APPLICATION FOR PERMISSION
UNDER SECTION 16 OF
THE TOWN PLANNING ORDINANCE
(CAP. 131)

For Official Use Only 請勿填寫此欄	Application No. 申請編號	A/NB-LYT/860
	Date Received 收到日期	2025-08-25

(a) Proposed use(s)/development 擬議用途/發展	Proposed Temporary Green Fuel Station (Electric Vehicle Charging Station for Electric Taxi) for a Period of 3 Years (Please illustrate the details of the proposal on a layout plan) (請用平面圖說明擬議詳情)

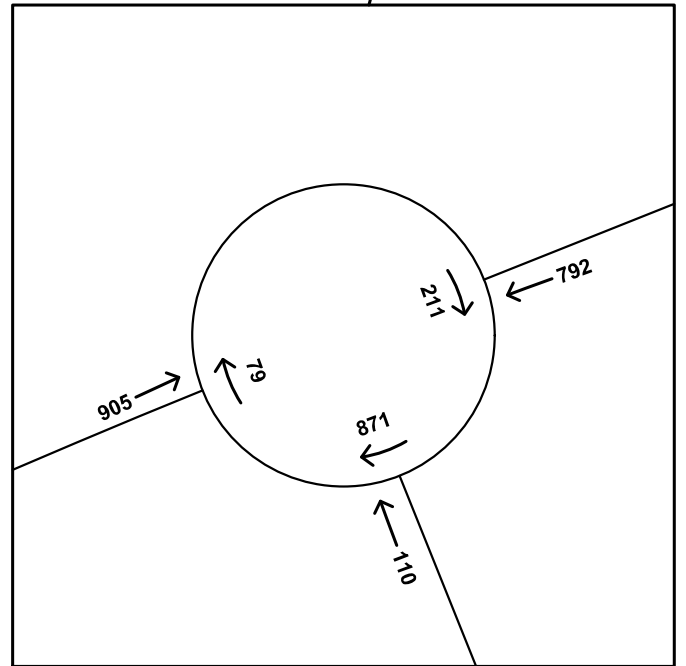
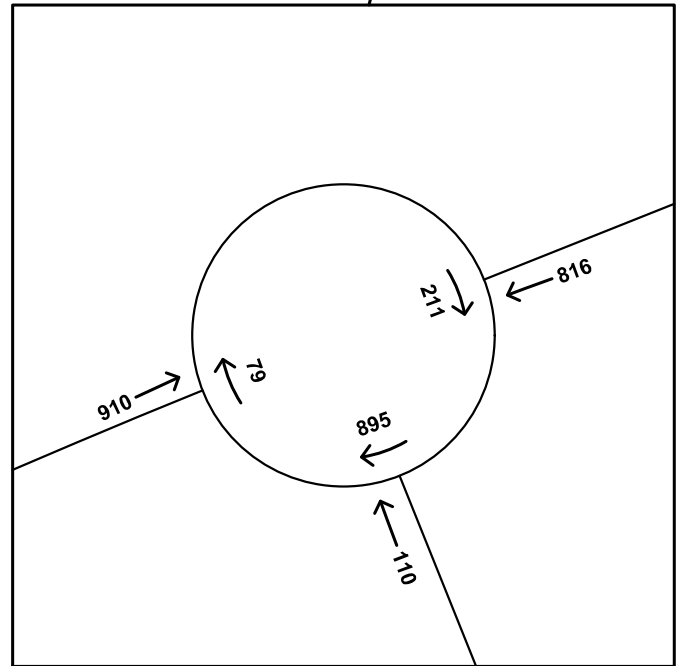
(h) Drawing nos. FIGURE 3.2, FIGURE 4.1, FIGURE 4.2 and FIGURE 4.3: The applicant should supplement the	(h) Noted. Figures 3.2, 4.1, 4.2 and 4.3 are updated to show the breakdown of flows for each traffic direction at each arm of the junctions. Please refer to the updated TIA report for details.
